Advisory

Upgrade / Repair / Retrofit

## UV Bulb Replacement

ProCure

Top View of ProCure Chamber

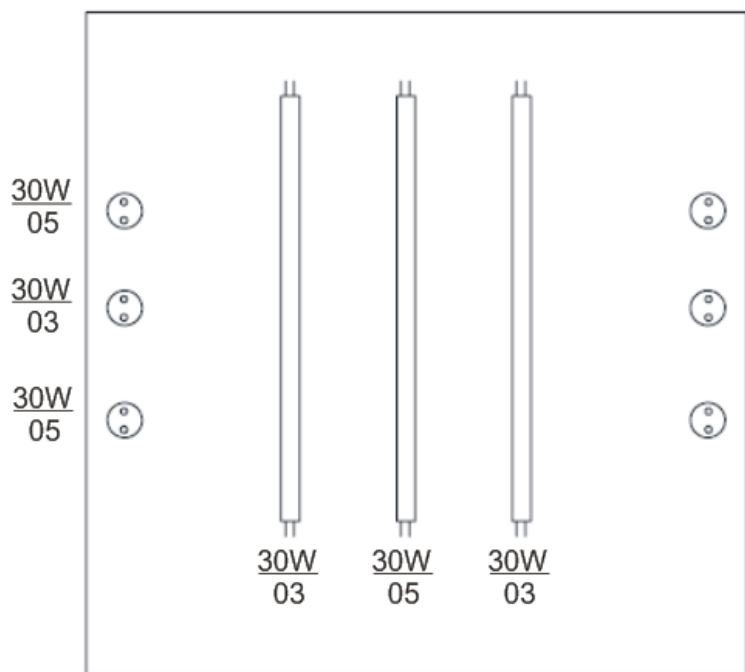
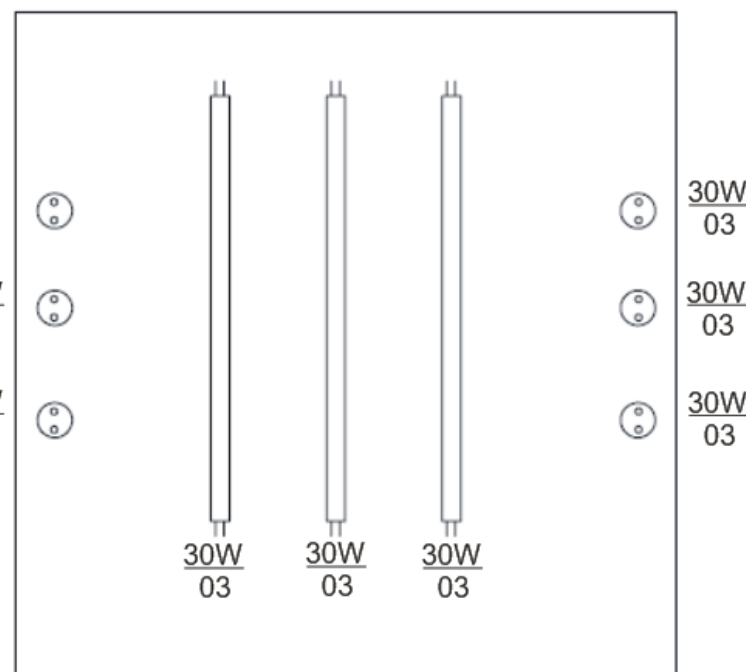
<b>ProCure Model</b>	P/N 23363-126-00 (Philips 30W/03)	P/N 23363-139-00 (Philips 30W/10)
ProCure 350 (P/N 23363-101-00)	Quantity 8	Quantity 1

New Bulb Layout

Front View of ProCure Chamber

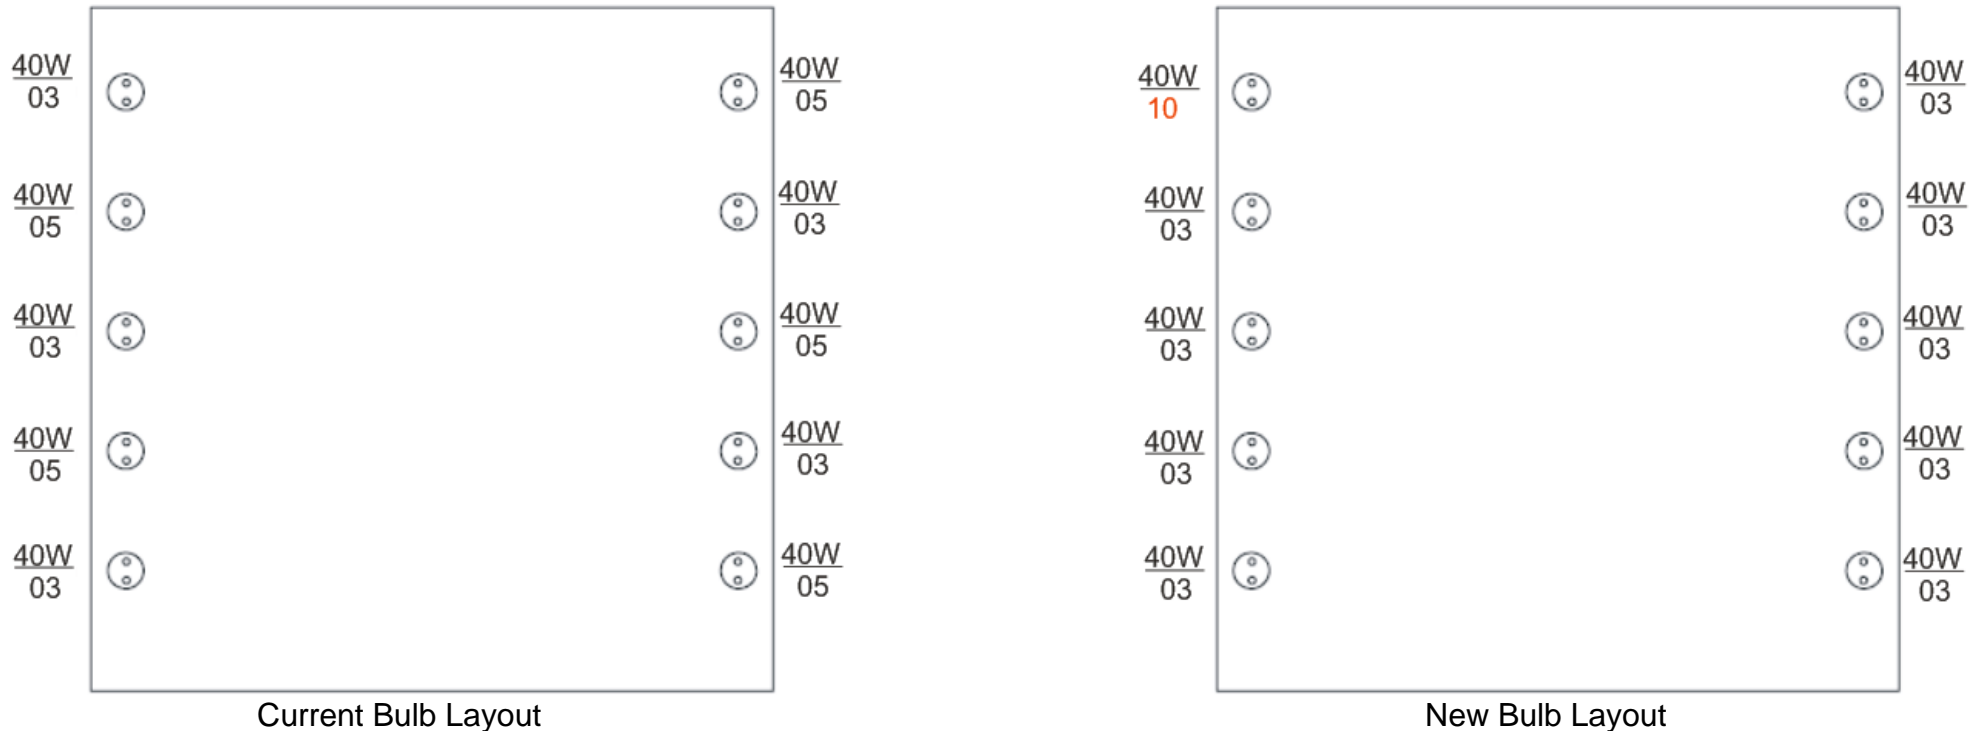
ProCure Model	P/N 16965-101-00 (Philips 40W/03)	P/N 23365-132-00 (Philips 40W/10)
PCA-250 (P/N 16990-9XX)	Quantity 9	Quantity 1
PCA-350 (P/N 20478-901)	Quantity 9	Quantity 1
PCA-350/3500 Assy, CE (P/N 21556-902)	Quantity 9	Quantity 1

Top View of ProCure Chamber

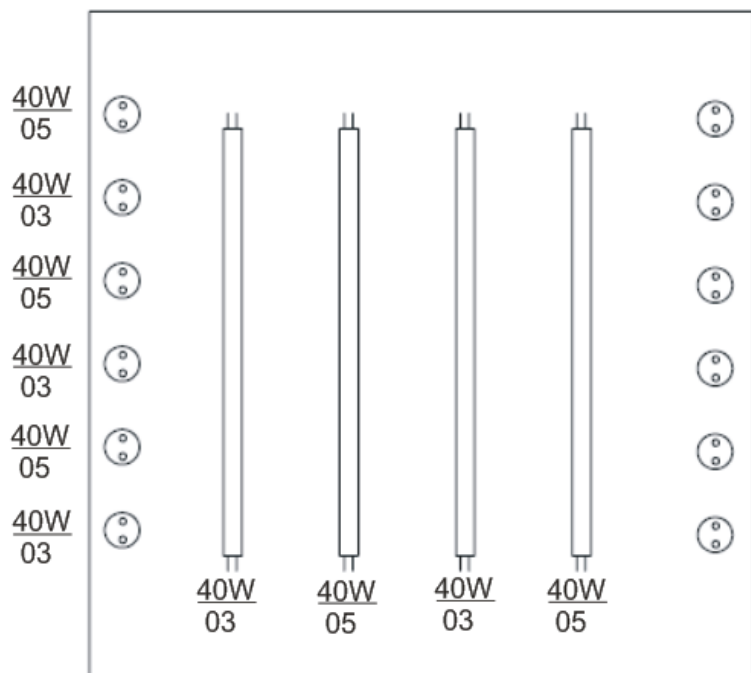
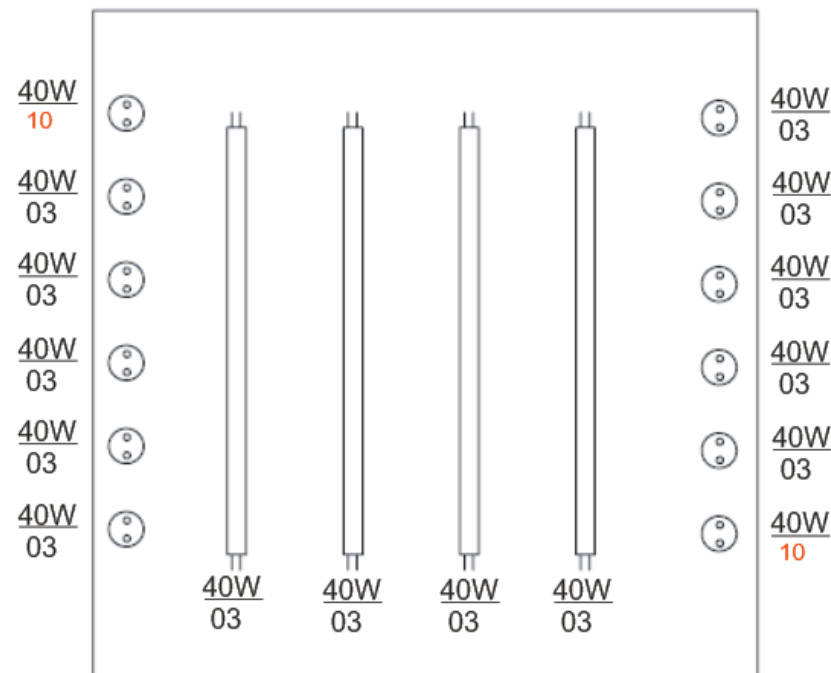
ProCure Model	P/N 16965-101-00 (Philips 40W/03)	P/N 23365-132-00 (Philips 40W/10)
PCA 500 System (20795-901-00)	Quantity 14	Quantity 2
PCA-500/5000/7000, CE ( 21431-903)	Quantity 14	Quantity 2

New Bulb Layout

Top View of ProCure Chamber

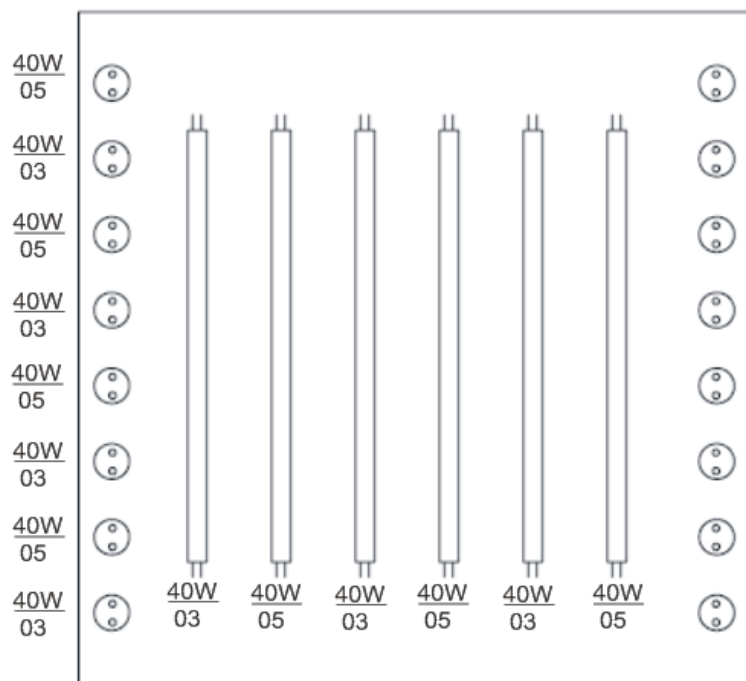
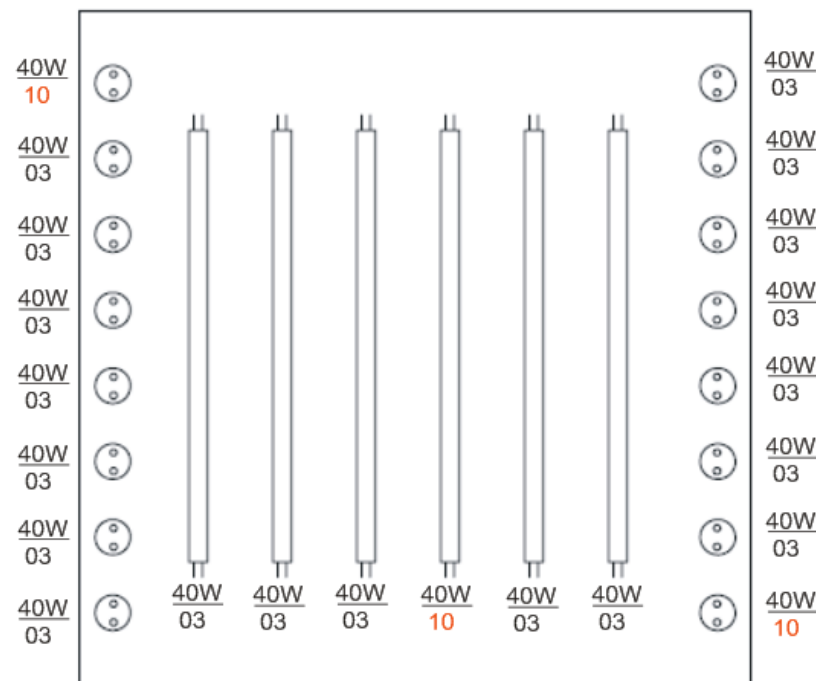
<b>ProCure Model</b>	P/N 16965-101-00 (Philips 40W/03)	P/N 23365-132-00 (Philips 40W/10)
ProCure 750 (23365-101-00)	Quantity 19	Quantity 3

New Bulb Layout
